Technical Service Information

THM 3T40 (125C) TCC FILTER ADDED

Figure 1

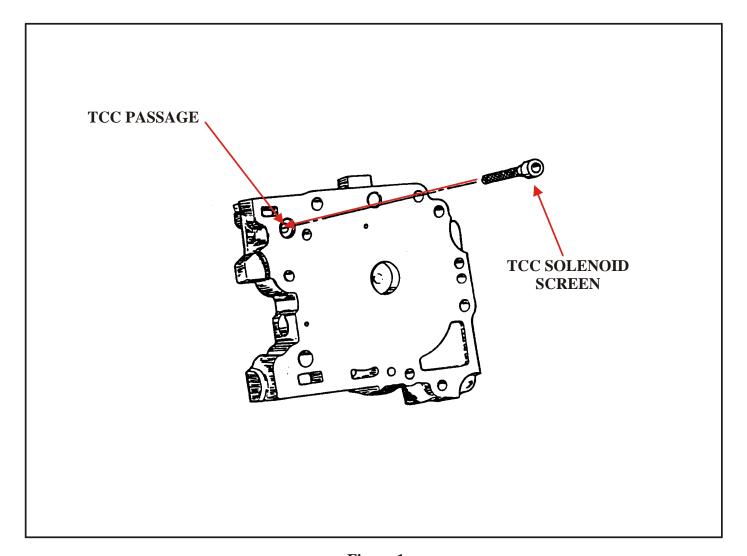
A TCC filter has been added to the TCC signal passage in the auxiliary valve body, beginning in March, 1987 (See Figure 1). This will reduce the possibility of sediment entering the TCC solenoid.

If the solenoid gets contaminated with sediment, it could result in a complaint of engine stalling when selector is placed in drive or reverse.

The filter cannot be used in previous models because of a machining process needed on the auxiliary valve body.
